Product / Process Change Notification (PCN)

PCN #: PCN_WCAP-AS5H_20230629
Affected Series: WCAP-AS5H;
 P/N 865230564010; 865230657014
PCN Date: March 29, 2023
Effective Date: June 29, 2023

Old Drawing with "6.1 ± 0.3" dimension in datasheet 865230564010

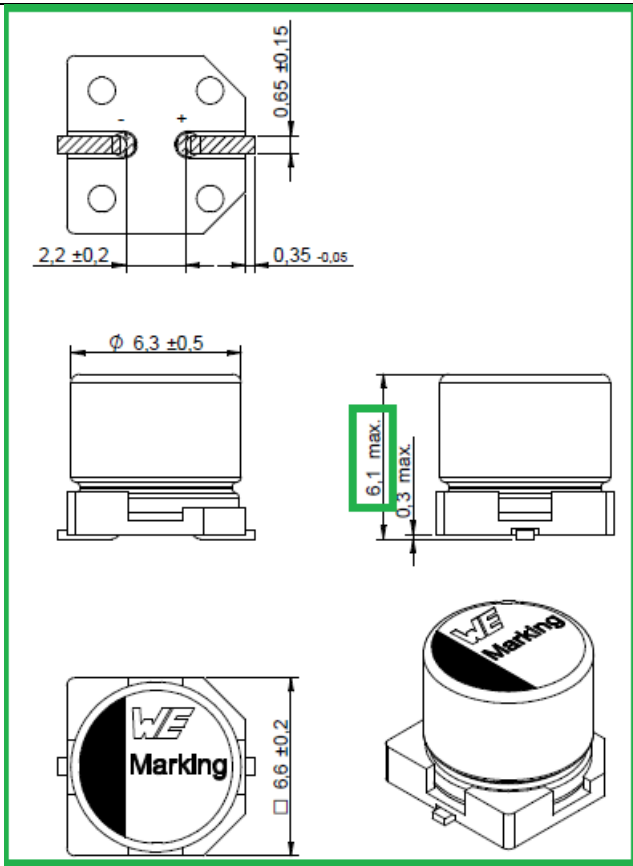
- Würth Elektronik will correct the height for 865230564010 from "6.1±0.3" into "6.1 max".

Below is the specification of change for P/N 865230564010, old and new drawings are shown below in order to visualize the updates of the height.

New Drawing with "6.1 max" dimension in datasheet 865230564010
